FIRE SAFETY INSPECTION REPORT
Interfab Shirt Manufacturing Ltd (Unit-2)
Stoffatex Fashion Ltd.

ACCORD ID: 23717

Fire Safety Inspection Report

Factory Name: Interfab Shirt Manufacturing Ltd (Unit-2)

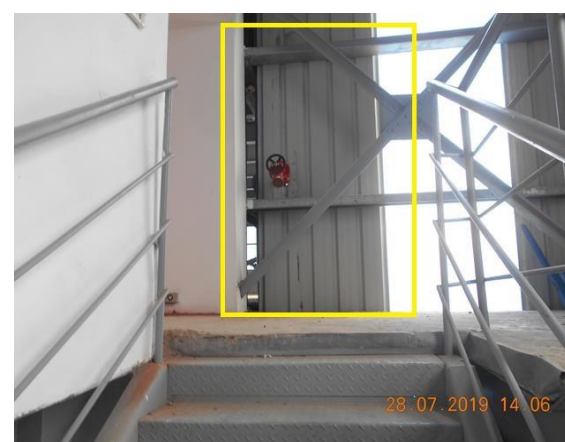
Sl No.	Category	Findings	Required Action	Remediation Time Frame
F-1	Fire Rated Construction	Areas used for in-process storage of combustible materials are open to the surrounding occupancy .	Provide defined storage areas and limit the storage arrangement as follows:- 1. General Condition: Maximum height of 2.4m and maximum area of 23m². Separate areas of unenclosed combustible storage by a minimum clear distance of 3m. 2. If sprinkler protected: maximum height of 3.66m and maximum area of 93m². Separate areas of unenclosed combustible storage by a minimum clear distance of 3m. or 3. Enclose the storage area from the surrounding occupancy with a minimum 1 hour construction.	Within 3 months

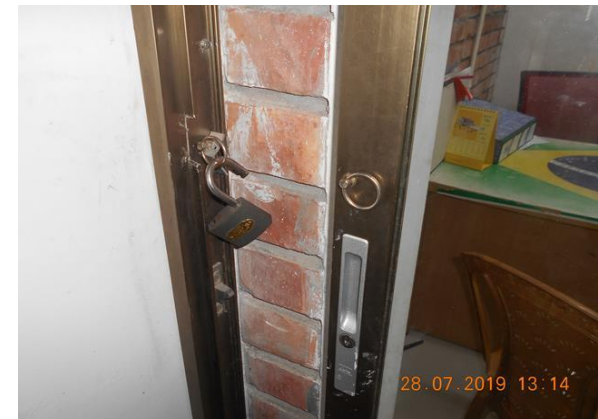
F-5	Egress	Handrails are provided in the exit stair but height is 48 inch from the leading edge of the tread.	Provide handrails have a minimum height of 865 mm (34 in.) and a maximum height of 965 mm (38 in. as measured from the leading edge of the tread.	Within 3 months
-----	--------	--	---	-----------------
